FEBRUARY 2020

PL6

NON MATERIAL  
AMENDMENT  
PLANNING  
APPLICATION  
& CONDITION 4  
DISCHARGE

44 A GLOUCESTER  
AVENUE LONDON  
NW1 8JD

173\_PL1\_SS\_01\_P  
PROPOSED REAR COURTYARD

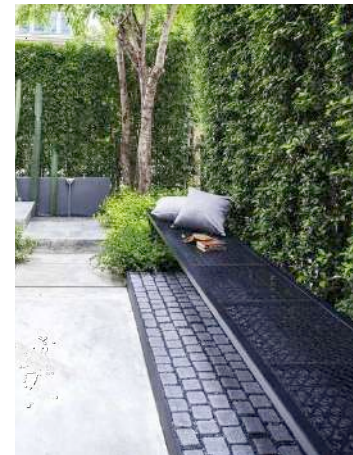
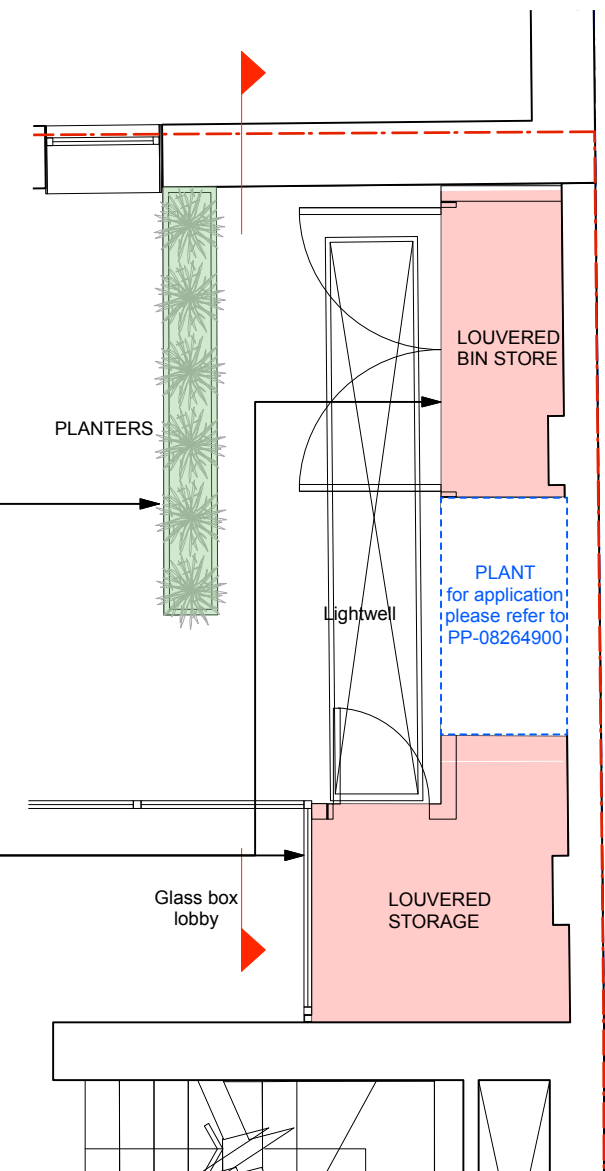
**Planters**

**Aluminium Power Coated Louvers**  
RAL colour 7043  
For Acoustic Spec refer to Full  
Planning Application PP-08264900

# 3.2 ADDITIONAL INFORMATION- NEW MATERIALS

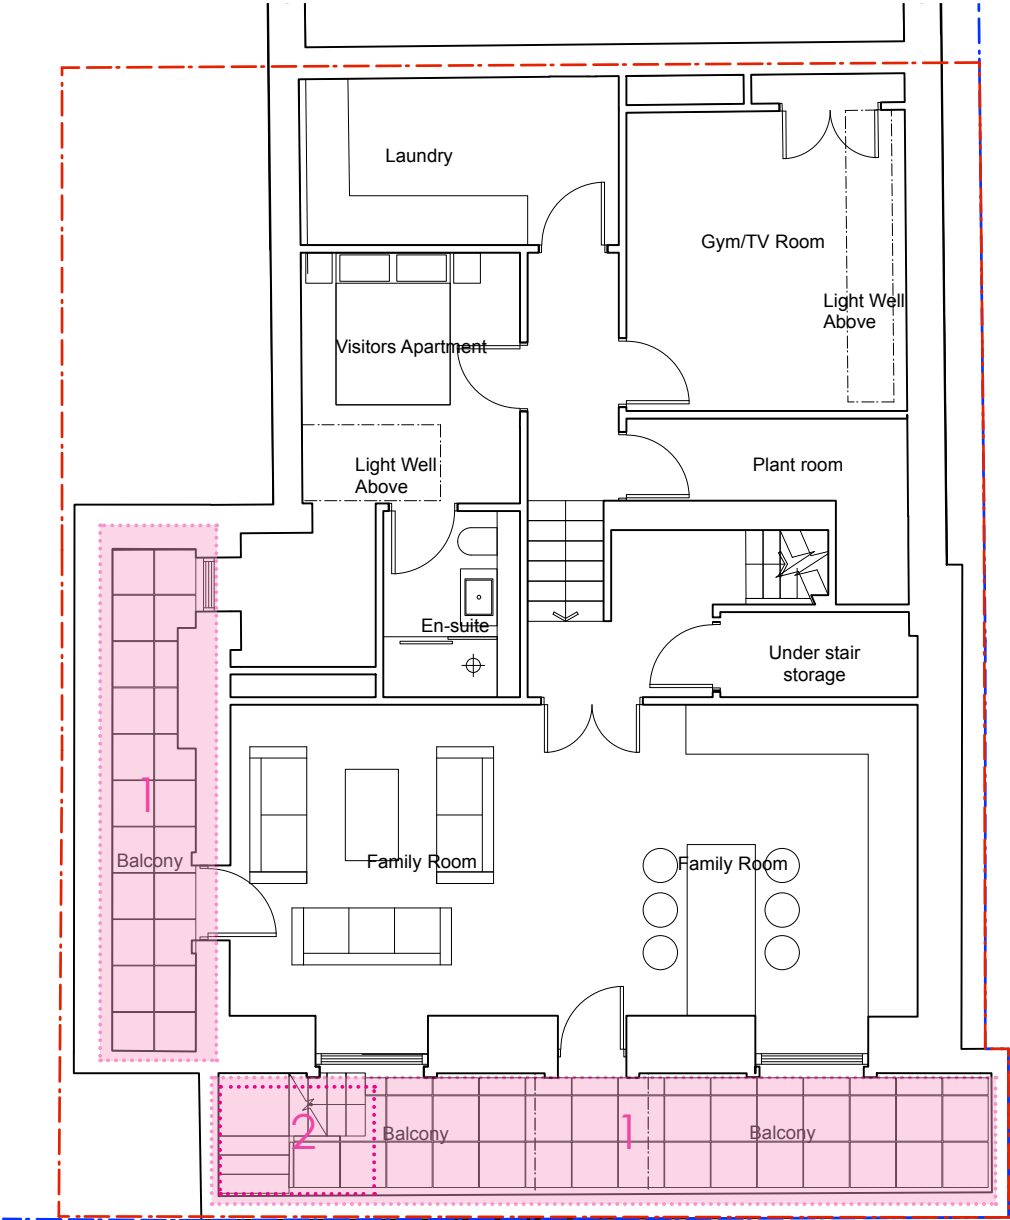
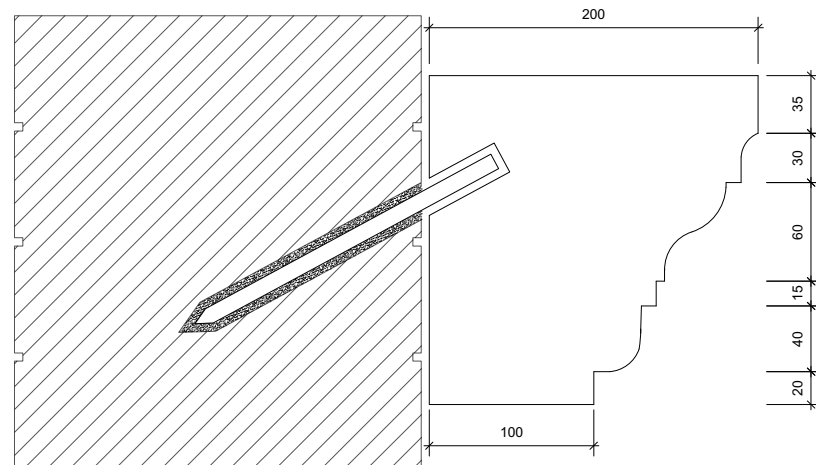
1. Balconies (lightwells) to the side and front elevation of the house have paving which is deteriorating and in poor state. Proposal includes those pavers to be Yorkstone to match the original intended design,

2. Existing external staircase is in poor condition and we are proposing complete replacement of the existing staircase. Proposal would include staircase to have matching metal handrail and Yorkstone threads as per intended original design.

# 4.1 CHANGES TO CONDITION 4 FRONT ELEVATION

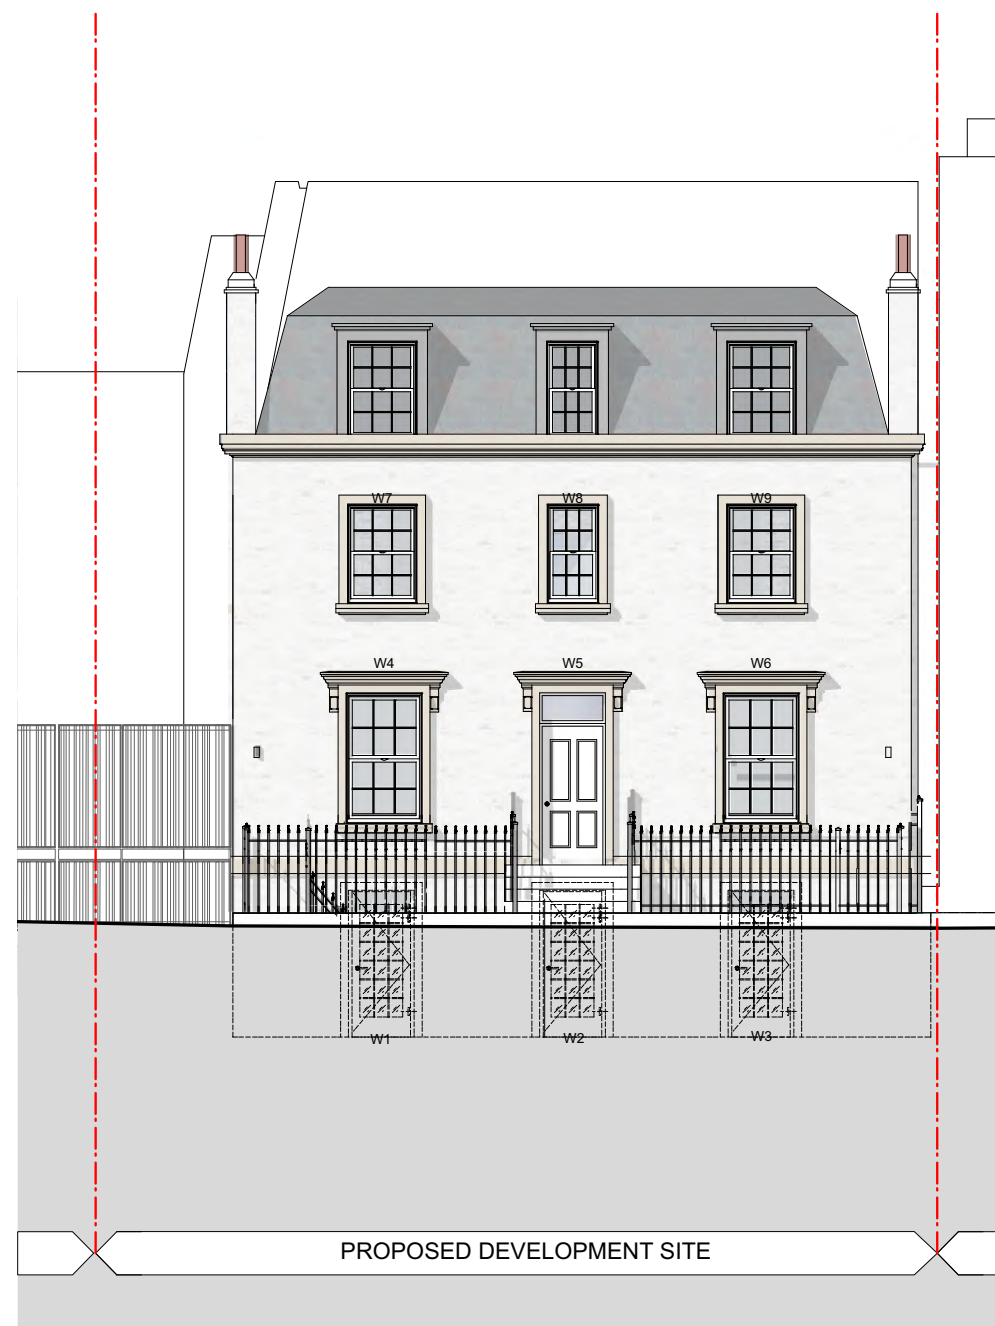
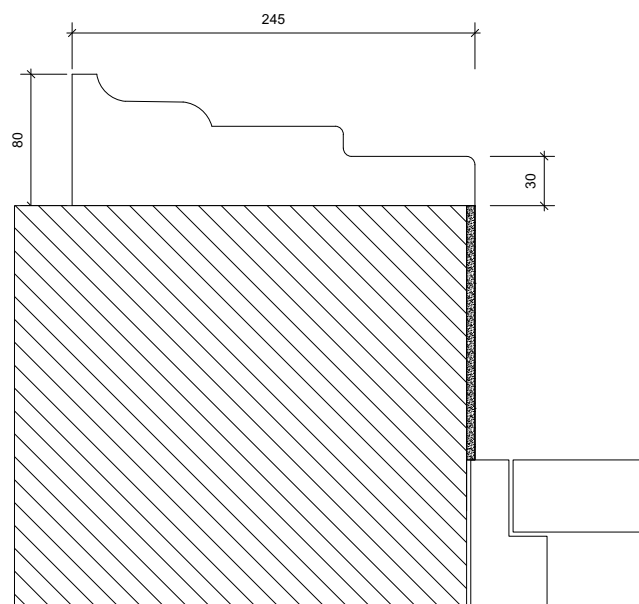
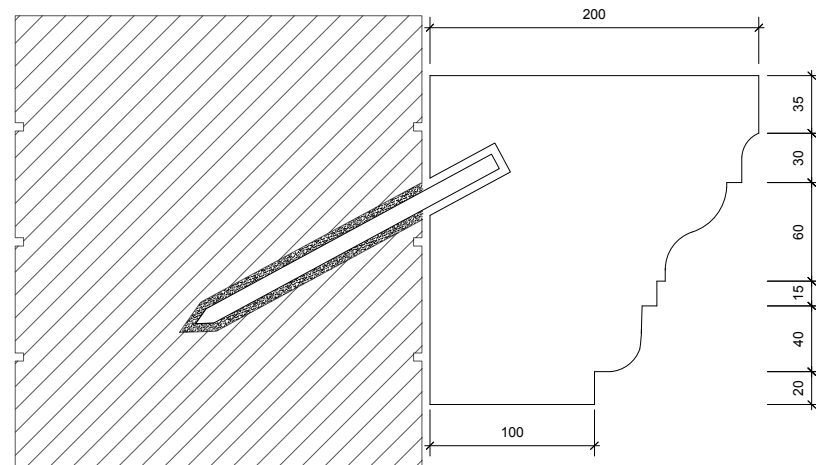
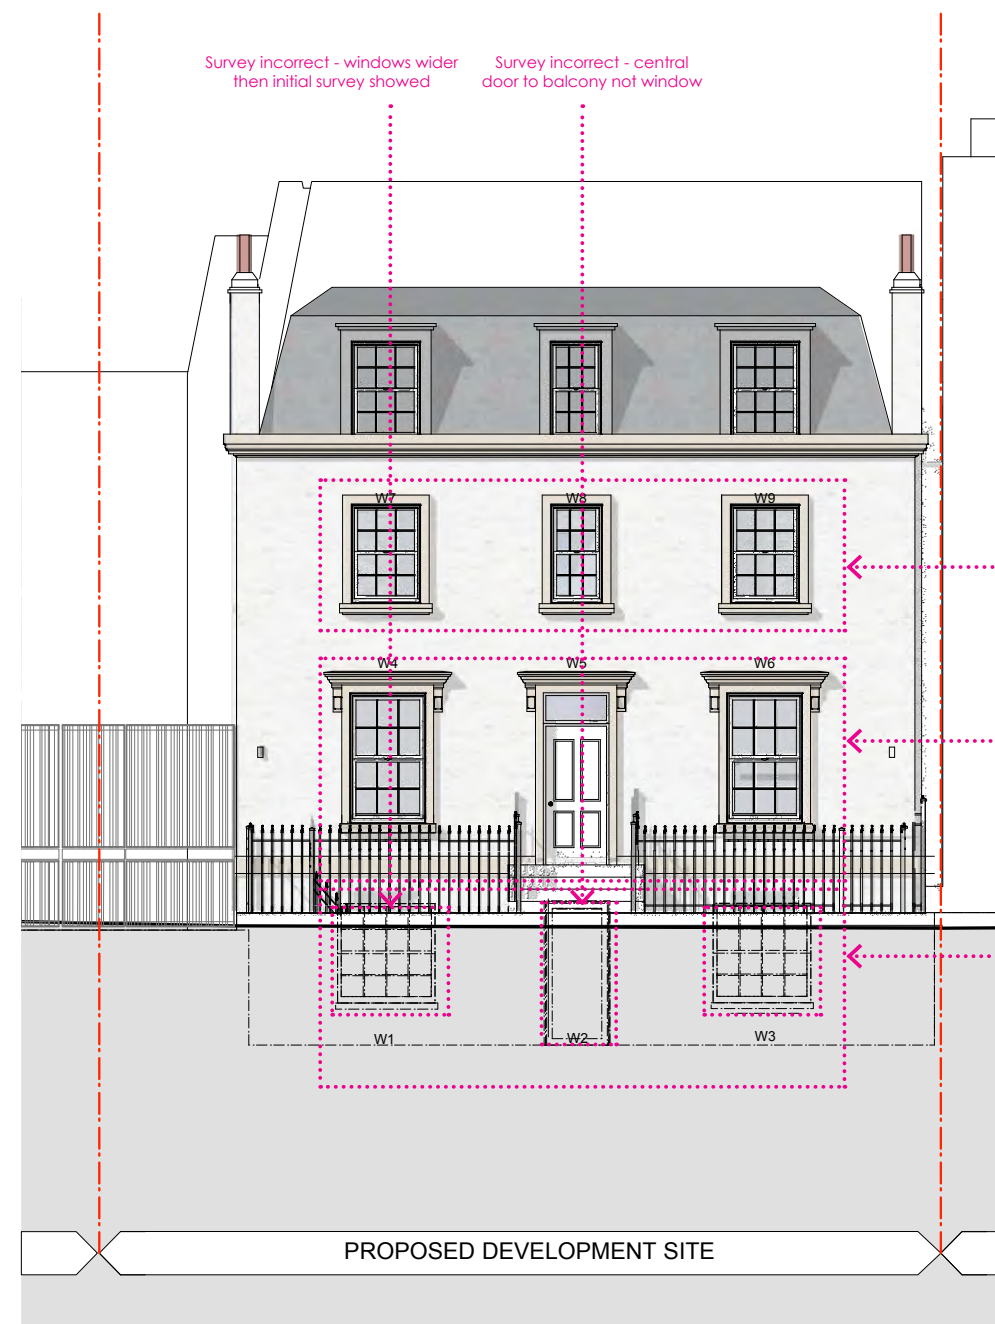
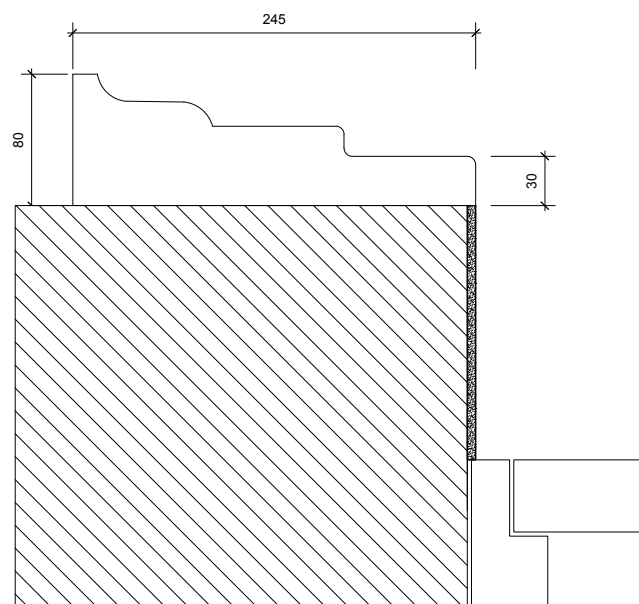
**BASEMENT WINDOWS (W1 and W3)**  
Existing Cill to be removed, as they have significant cracks, with a new stone cill formed with upstand to receive window.  
Profile to be added to the frame on three sides oversailing the existing base to the reveal.

**BASEMENT DOOR (W2)**  
Existing concrete plinth to be clad over with a new stone cill.  
Profile to be added to the frame on three sides oversailing the existing base to the reveal.

**GROUND FLOOR WINDOWS (W4 and W6)**  
Existing cill to be removed, as they have significant cracks, with a new stone cill formed with upstand to receive window.  
Profile to be added to the frame on three sides oversailing the existing base to the reveal.  
The rolls and entablatures to be fixed through the wall beyond the frame.

**ENTRANCE DOOR (W5)**  
Existing concrete plinth to be clad over with a new stone cill.  
Profile to be added to the frame on three sides oversailing the existing base to the reveal.  
The rolls and entablatures to be fixed through the wall beyond the frame.

**FIRST FLOOR WINDOWS (W7 - W9)**  
Existing Cill to be removed, as they have significant cracks, with a new stone cill formed with upstand to receive window.  
Profile to be added to the frame on three sides oversailing the existing base to the reveal.

Consented documents discharging condition 4 have been approved considering window cills and the surrounds for the windows to be Yorkstone.  
New proposal includes stone to be **Portland stone** to match the original design

# 4.2 CHANGES TO CONDITION 4 SIDE ELEVATION

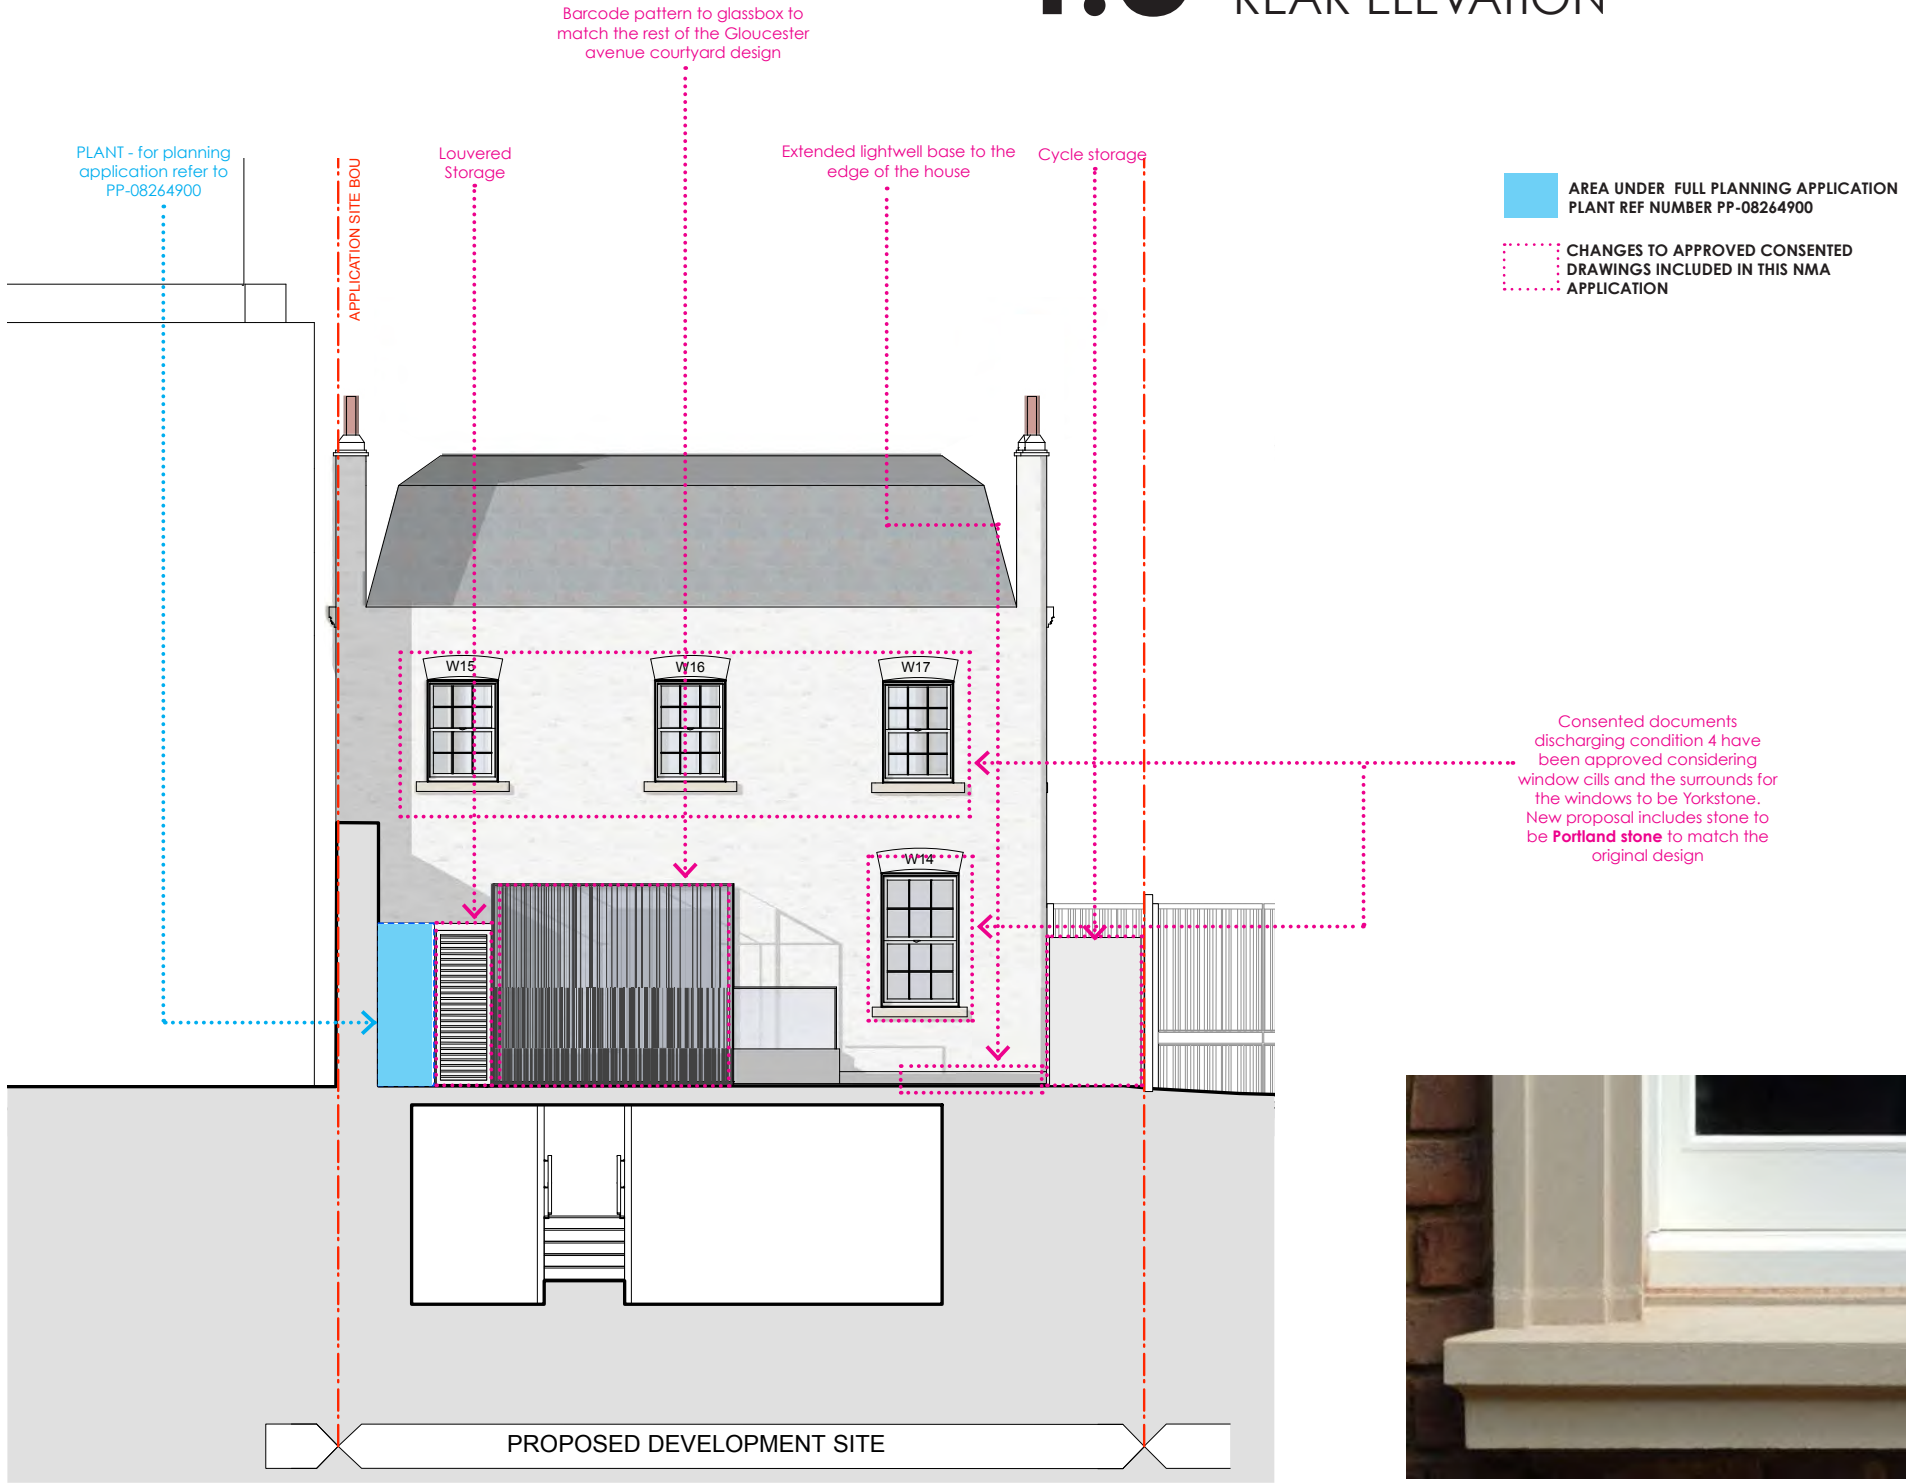
New cills to be provided as there are not enough existing cill which can be salvaged and re-used.

Consented documents discharging condition 4 have been approved considering window cills and the surrounds for the windows to be Yorkstone. New proposal includes stone to be **Portland stone** to match the original design
